Appendix 18.14: Consultation

RAIL CENTRAL - NOISE AND VIBRATION - BASELINE MONITORING AND IMPACT ASSESSMENTS TO BE UNDERTAKEN

Description Rail Central SRFI - Noise and Vibration Issues raised by South Northants Council – Spectrum’s further responses

Ref No ARC6820/14006/Rev 2

PROJECT
NINE POTENTIAL NOISE AND VIBRATION MEASUREMENT POSITIONS

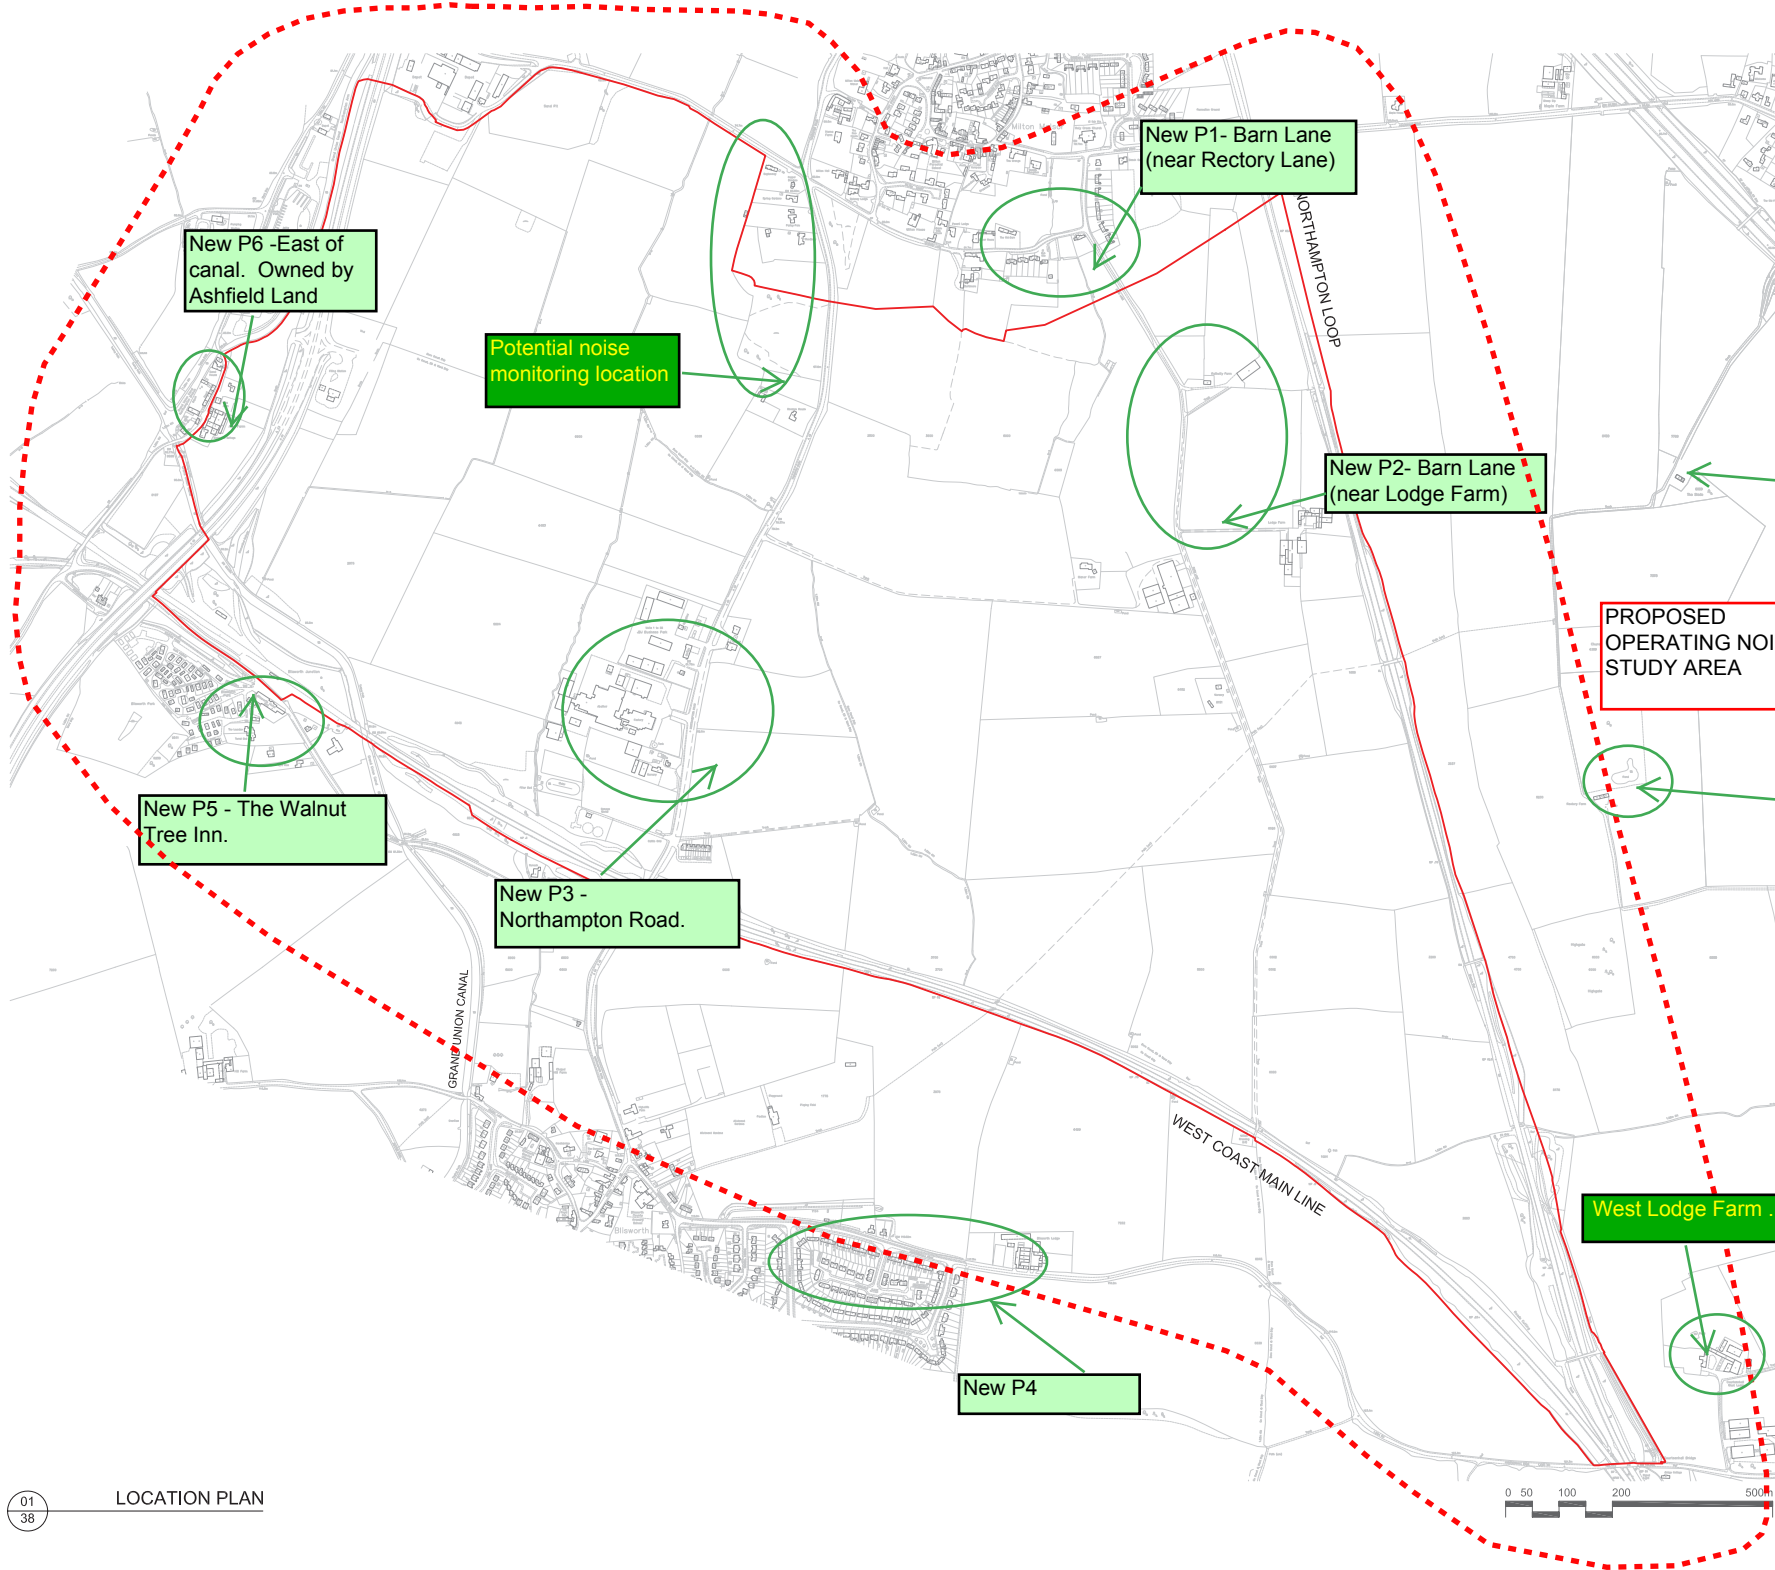
We attach a plan of potential unmanned N and V monitoring positions. This follows our earlier short sample of attended measurements made last year and reported within the scoping report. The circular zones identified in green on the attached plan identify groups of potential sensitive receptors for which we are considering obtaining baseline noise data – the positions selected are generally indicated by the arrowhead of each text box, and is sometimes farmland. Where Ashfield Land own residential property, we may be able to use measurement positions within private garden areas. These discussions are currently ongoing with landowners but should be resolved shortly.

This building needs to be confirmed as no longer residential.

Figure 1 – Noise and vibration baseline monitoring locations.

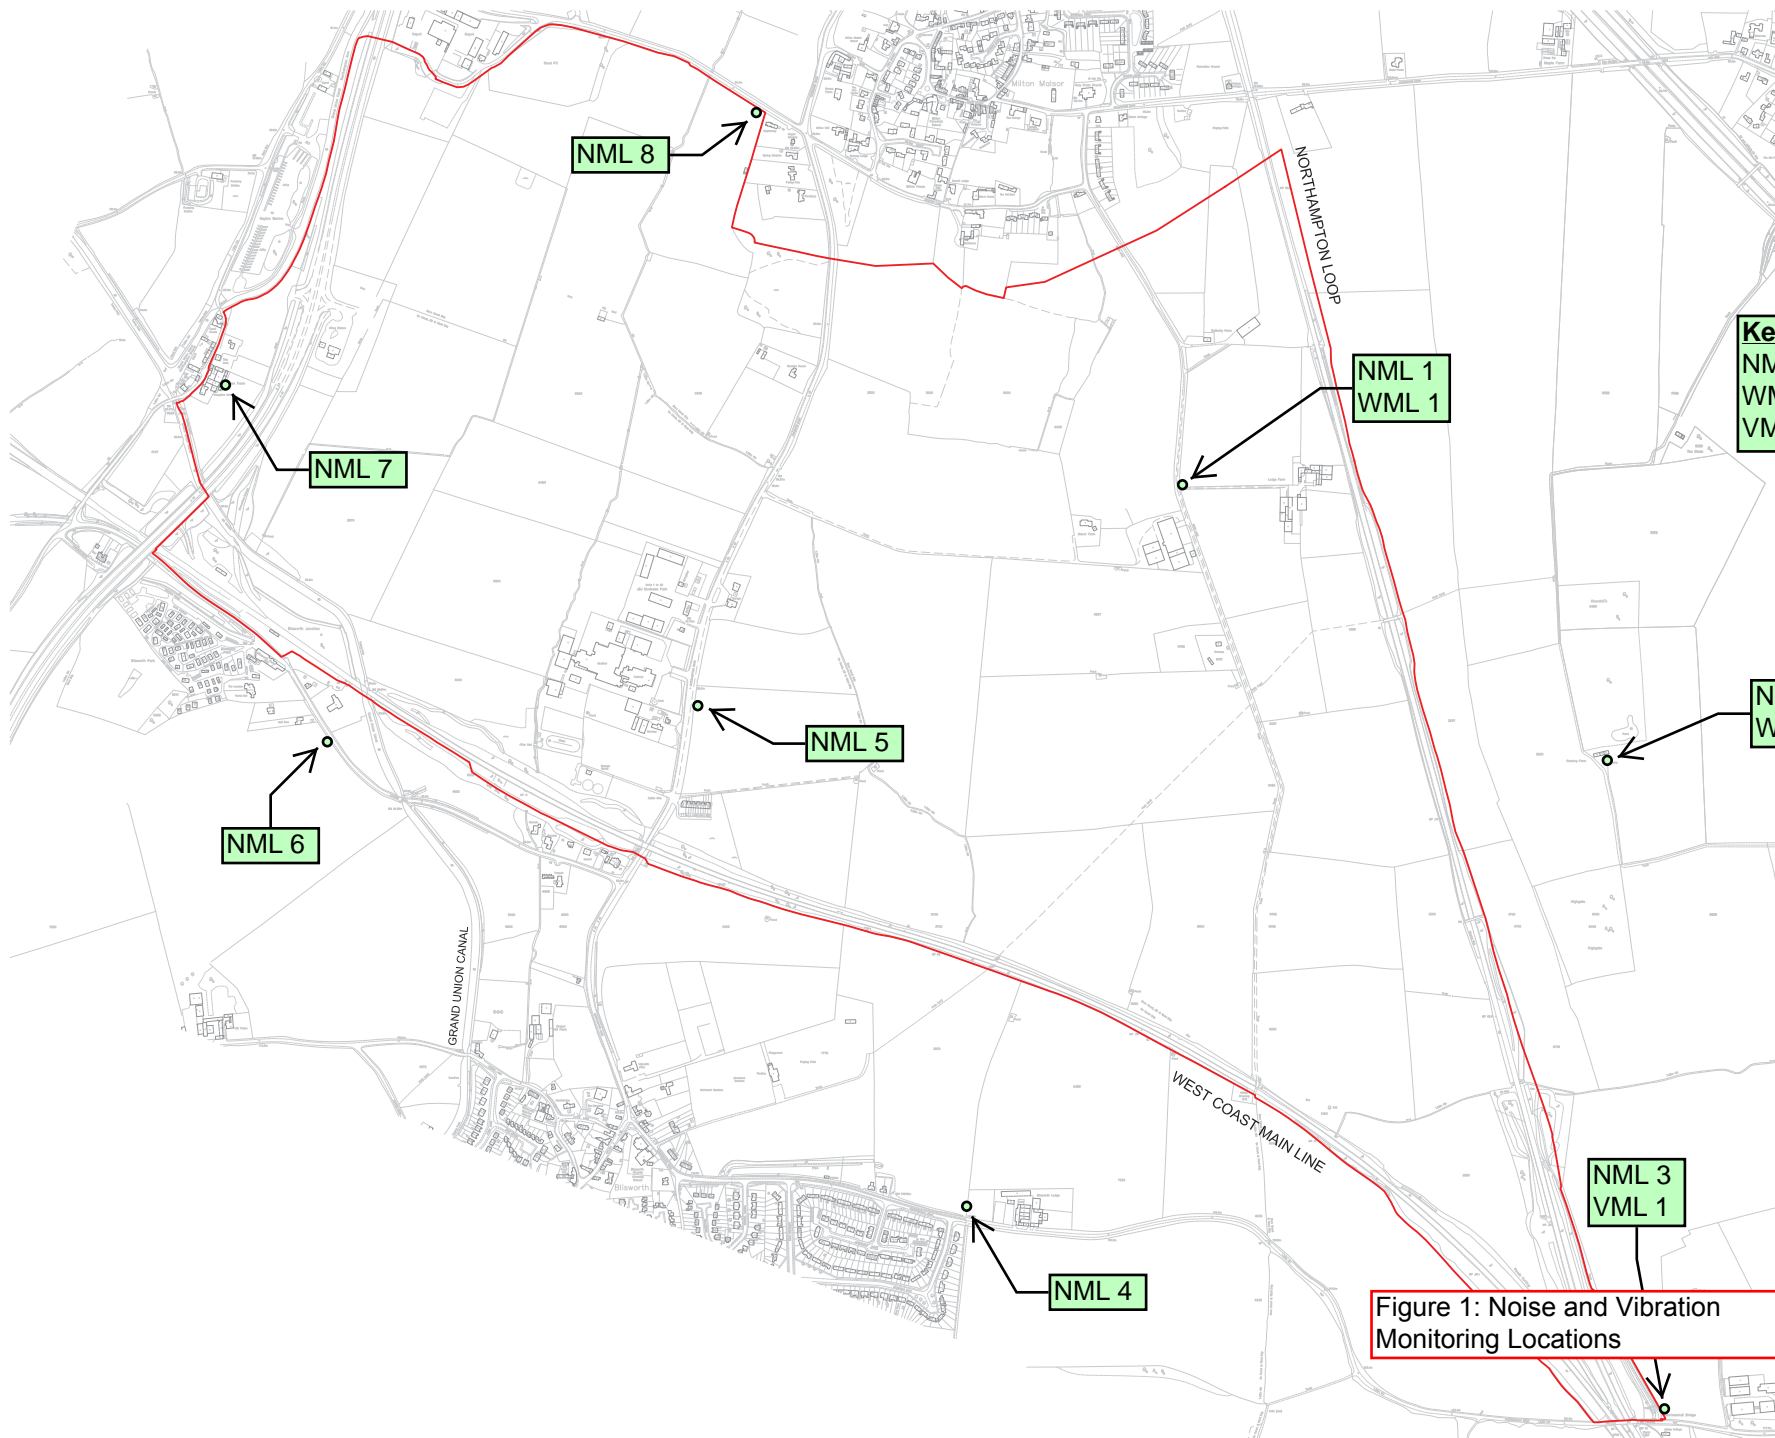
We have no objection to the methodology and choice of noise receptors as indicated on Figure 1 subject to their approval by the Canal & River Trust. The Canal & River Trust scoping opinion response questioned whether there are likely to be any vibration effects in respect of the canal infrastructure.

Figure 2: Noise Sensitive Receptors

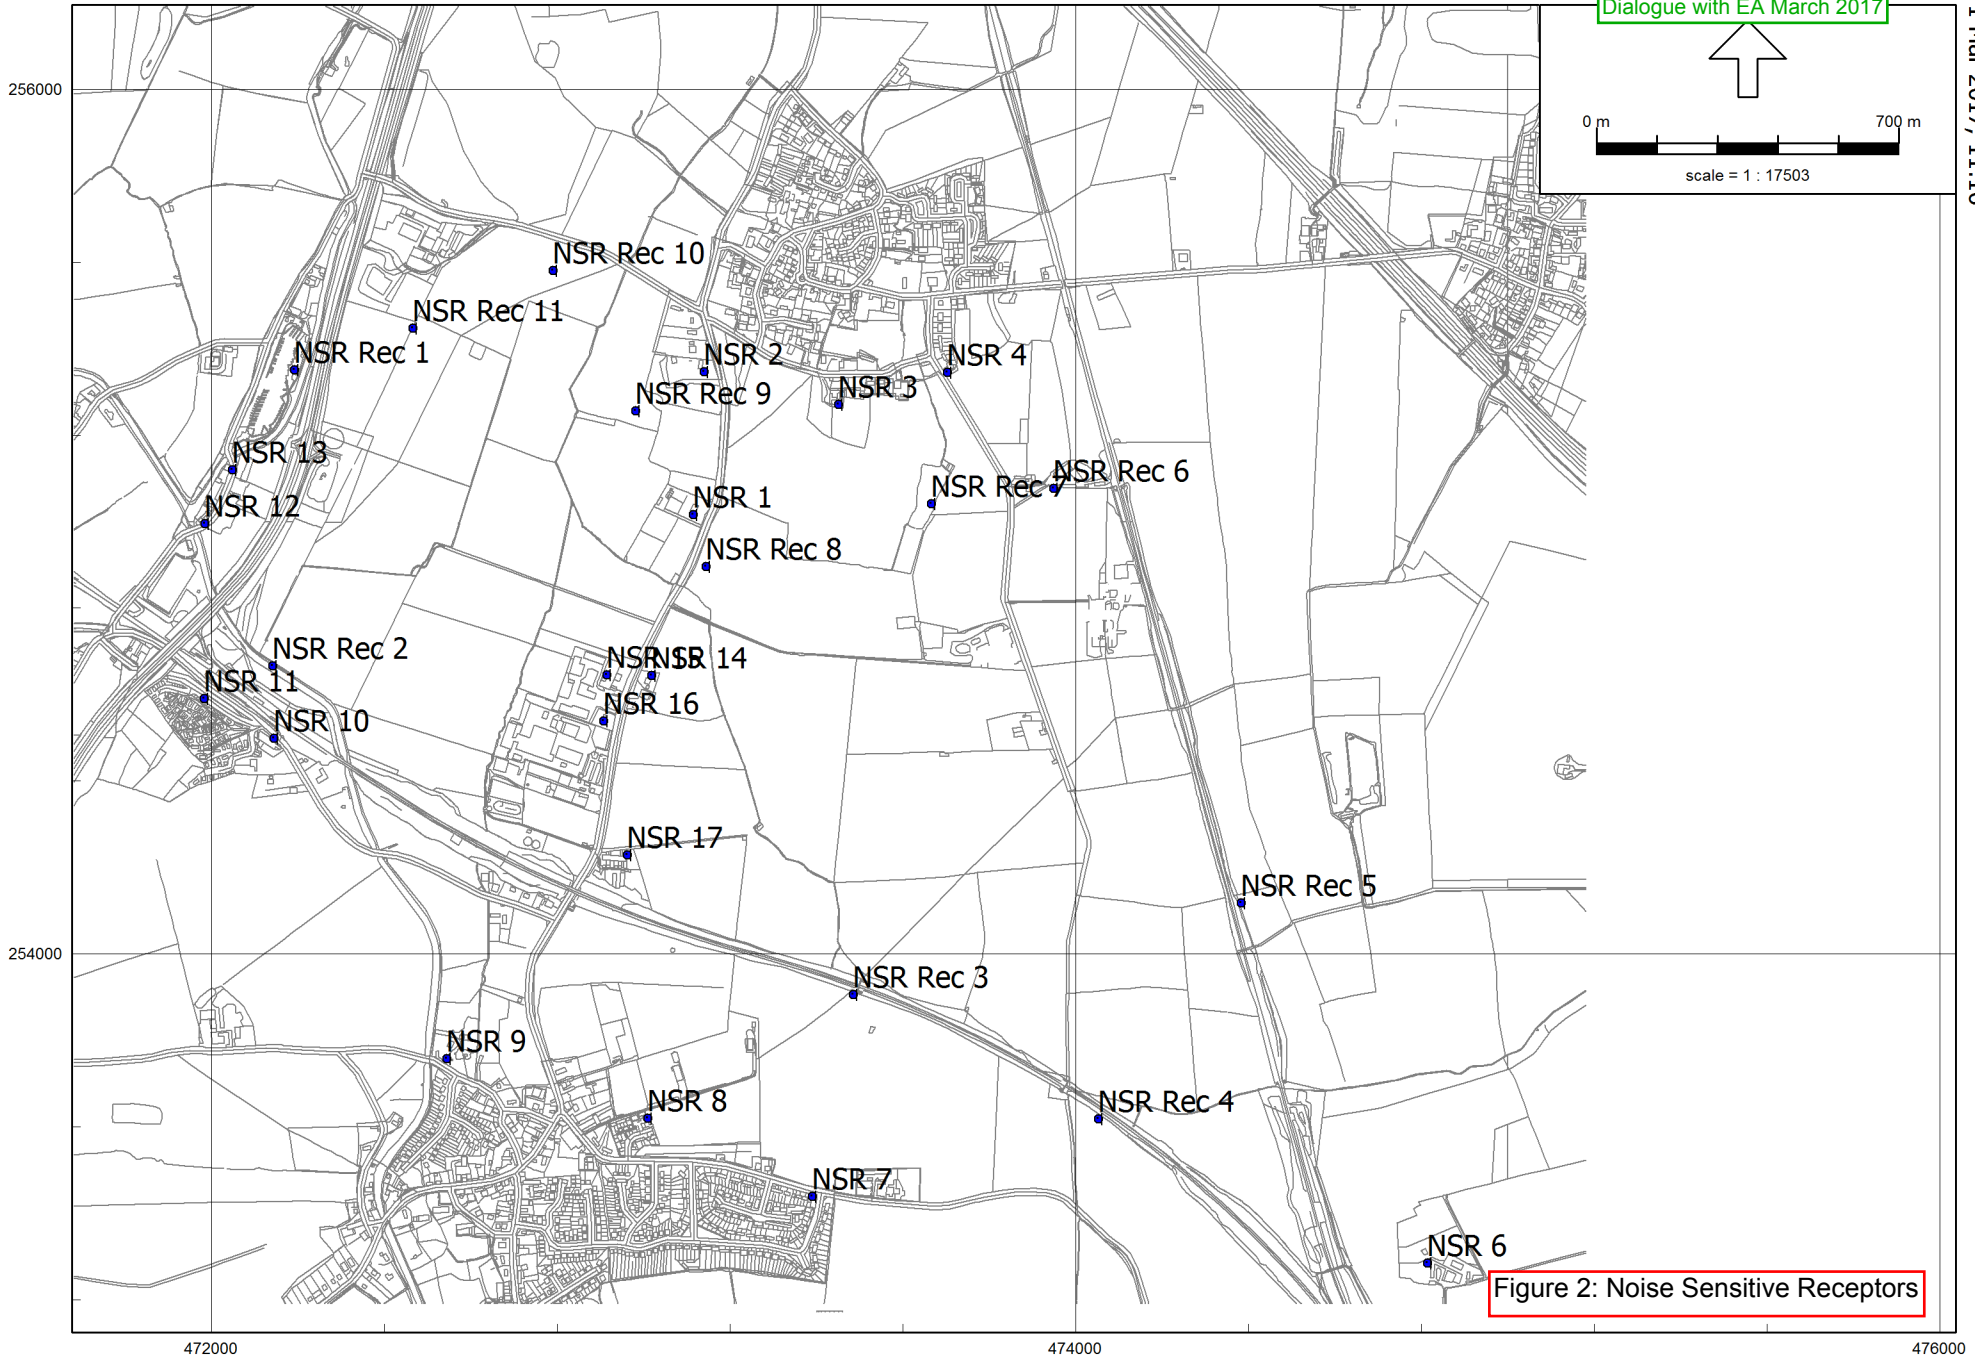
The scoping opinion and subsequent discussions with South Northamptonshire Council have also covered matters such as ensuring all potential noise sensitive receptors in the area are properly identified so that appropriate assessment can be carried out at each position. The location of noise sensitive receptors is shown in Figure 2 attached. The number of potential sensitive receptors is much greater than the number of monitoring positions, especially when amenity receptors are included. It is not practical to undertake long term baseline monitoring at each and every sensitive receptor, however the selection of monitoring locations has been made to be able to fully define the variation in background noise levels across the site and beyond so that where there are to be comparisons with baseline levels in the EIA, data will exist for this comparison obtained at a monitoring location nearby. Please note that in Figure 2, NSR 1- 17 are residential receptors and NSR Rec 1-11 are amenity/recreational receptors including footpaths and canal towpaths.
